MINOR PROJECT REFINEMENT REQUEST FORM

Request Number: 01
Date Requested: August 18, 2022
**Proposed Duration/
Timing of Use:** Upon approval through October 15, 2022
Daytime hours
Location: Access Route to Pole 57
APN: 018-194-042-000
Attached Map? Yes No

Client/Project 185705825
 PG&E Humboldt Bay-Humboldt #1 60kV
 Minor Project Refinement No. 1

Figure
 1

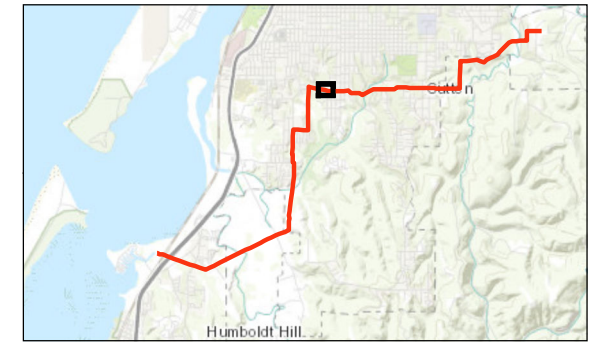
PG&E proposes to establish a new access route to access Pole 57 from the private residential driveway at 20 Silvertip Lane in Eureka, California (APN: 018-194-042-000). The proposed access route is located within the study area of the Final ISMND.

This minor project refinement would require limited grading along approximately 80 feet of the access route (totaling approximately 450 square feet) to level the surface and allow for the safe passage of equipment. The new access route would extend approximately 240 feet from the end of the paved residential driveway. PG&E's construction contractor completed approximately 3,000 square feet of vegetation clearing from the power line right-of-way including along the proposed new access route. Existing paved roads through a residential neighborhood would provide ground access to the new access route. The new access route will be restored consistent with the project Habitat Restoration Plan and SWPPP.

The access route is located within the biological resources study area included in the Final ISMND. No special status species, critical habitat, rare plants, or wetlands were identified within the proposed access route. As depicted in MPR Figure 1, approximately 3,000 square feet of vegetation (primarily Himalayan blackberry) has recently been cleared by the project construction contractor within the right-of-way and within the new access route footprint. No additional vegetation clearing would be required.

The proposed access route is located in a disturbed, residential neighborhood. As depicted in MPR Figure 1, approximately 3,000 square feet of vegetation within 150 feet of the right-of-way centerline has been cleared by the project contractor including the area proposed for the new access road. The cleared vegetation consisted primarily of Himalayan blackberry, California huckleberry, twinberry, and red alder.
